Response to Panel Request – FTAA-2603-1181 - Mt Welcome, Pukerua Bay, Porirua

Title	FTAA-2603-1181 - Mt Welcome, Pukerua Bay, Porirua – Response re Applicants Additional Stormwater Modelling
Location	• Pukerua Bay, Porirua
Authors	Zeean Brydon, Consultant Peer Reviewer, Land Development Consenting
Status	Final
Version	1.0

Item [13] – Extended Flood Modelling

Figure 1

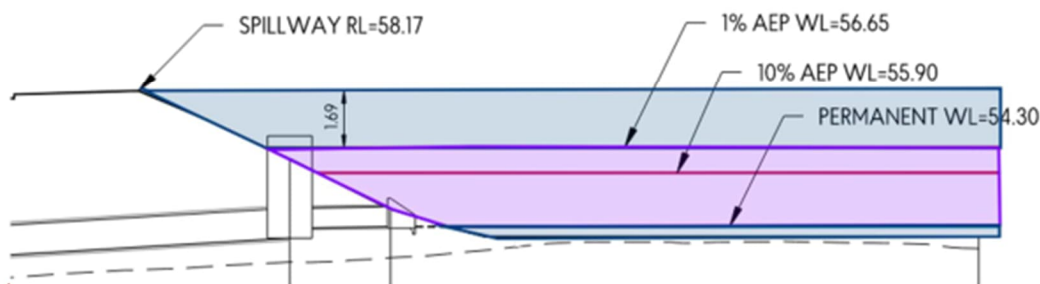
- 1% storage volumes provided do not appear to match the volumes provided on the Wetland Construction set (1753-02 4300 R2 series), comments are therefore provided in principle only.
- the modelling is based on 95% 'porosity' – i.e. no allowance for plant growth within the wetland. By comparison modelling for Plim merton Farm included a reduction factor of 0.75 (or a 25% reduction for plant growth)¹

Sediment accumulation above the design permanent water level will impact on the outlet structure, culvert arrangement and fish passage. Using the example provided by the applicant (retention wetland B). Sedimentation above the green line (35 – 80 years as identified within the applicant's literature review) will impact on the existing outlet structure. Requiring either sediment renewal of the outlet structures and culverts, with new culverts required through the embankment, including for wetland B relaying a new culvert beneath the road and past the wastewater mitigation. Installation of

new culverts through the embankments has the potential to compromise the embankment stability and may impact on fish passage if culverts are steepened.

16. It is Tiaki Wai's position that consideration of sediment management should therefore extend beyond a simple volumetric storage-loss assessment. The appropriate assessment should demonstrate how sediment will be intercepted, monitored and, where necessary, removed throughout both the construction build-out phase and long-term operational phase, while maintaining the functionality of outlet structures, hydraulic controls, fish passage provisions and ecological values.

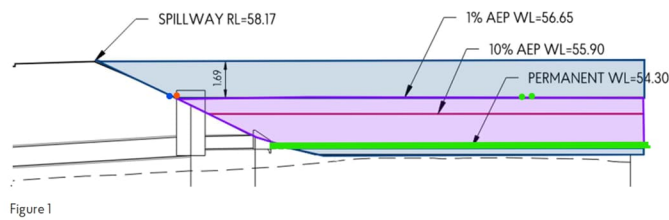
- The rate at which sedimentation will occur – Whilst the assessment states that sediment inflow will be low this appears to be a comparison of pre and post sediment loading and is not considered to be substantiated. As per the Engineering Joint Witness Statement there is no agreement as to the rate at which sedimentation will occur.

The Engineering JWS agreed that sediment sources include not only roads and roofs, but also erosion from open watercourses downstream of the pipe outfalls, existing unstable slopes, ongoing farming activities and potential scour between the discharge points and wetland systems. It was also agreed that the existing modelling framework is not suitable for quantifying these short-term scour and sediment transport processes. Accordingly, there remains uncertainty regarding the actual quantity, timing and location of sediment deposition within the proposed wetland systems.
